# **Pentium® Pro Processor Specification Update**

Release Date: January 1997

Order Number: 242689-024

**Figure 4-3. Stack Switch on a Call to a Different Privilege Level**

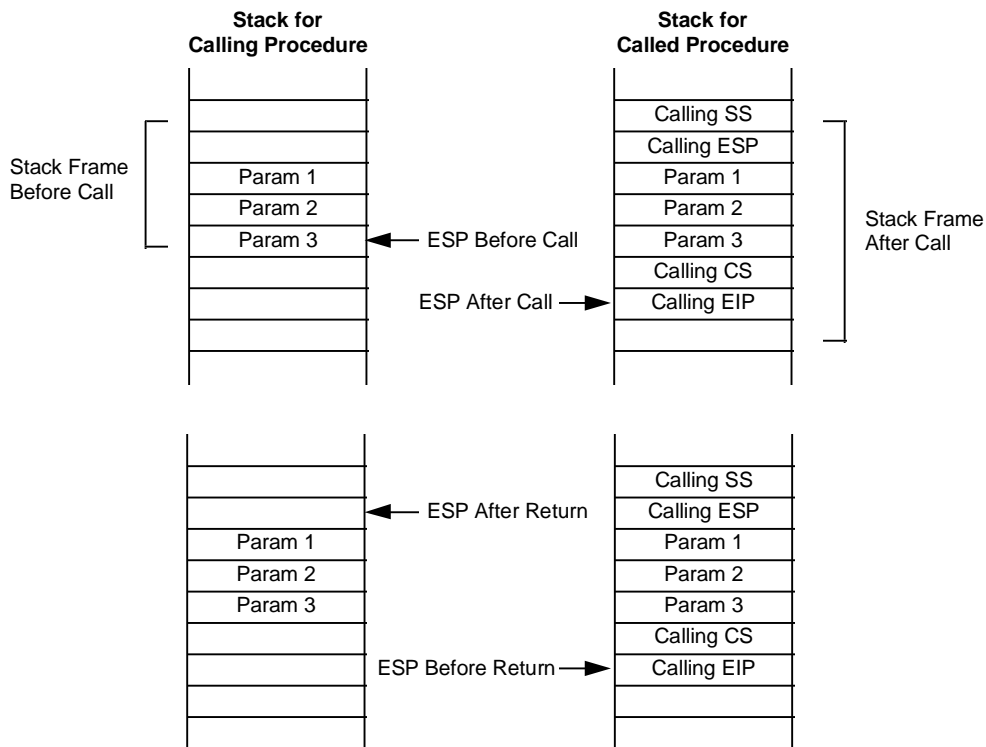
### 4.3.6. CALL and RET Operation Between Privilege Levels

When making a call to a more privileged protection level, the processor does the following (see Figure 4-3):

1. Performs an access rights check (privilege check).
2. Temporarily saves (internally) the current contents of the SS, ESP, CS, and EIP registers.
3. Loads the segment selector and stack pointer for the new stack (that is, the stack for the privilege level being called) from the TSS into the SS and ESP registers and switches to the new stack.

4. Pushes the temporarily saved SS and ESP values for the calling procedure's stack onto the new stack.
5. Copies the parameters from the calling procedure's stack to the new stack. (A value in the call gate descriptor determines how many parameters to copy to the new stack.)

**Figure 4-4. Stack Usage on Transfers to Interrupt and Exception Handling Routines**

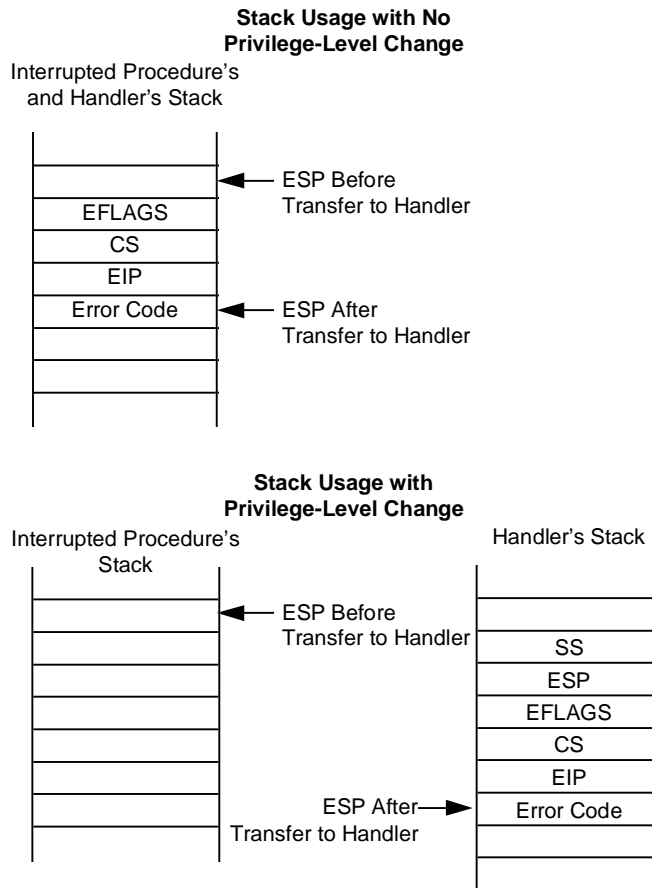
If no stack switch occurs, the processor does the following when calling an interrupt or exception handler (see Figure 44):

When executing a return from an interrupt or exception handler from a different privilege level than the interrupted procedure, the processor performs these actions:

1. Performs a privilege check.
2. Restores the CS and EIP registers to their values prior to the interrupt or exception.
3. Restores the EFLAGS register.
4. Restores the SS and ESP registers to their values prior to the interrupt or exception, resulting in a stack switch back to the stack of the interrupted procedure.
5. Resumes execution of the interrupted procedure.
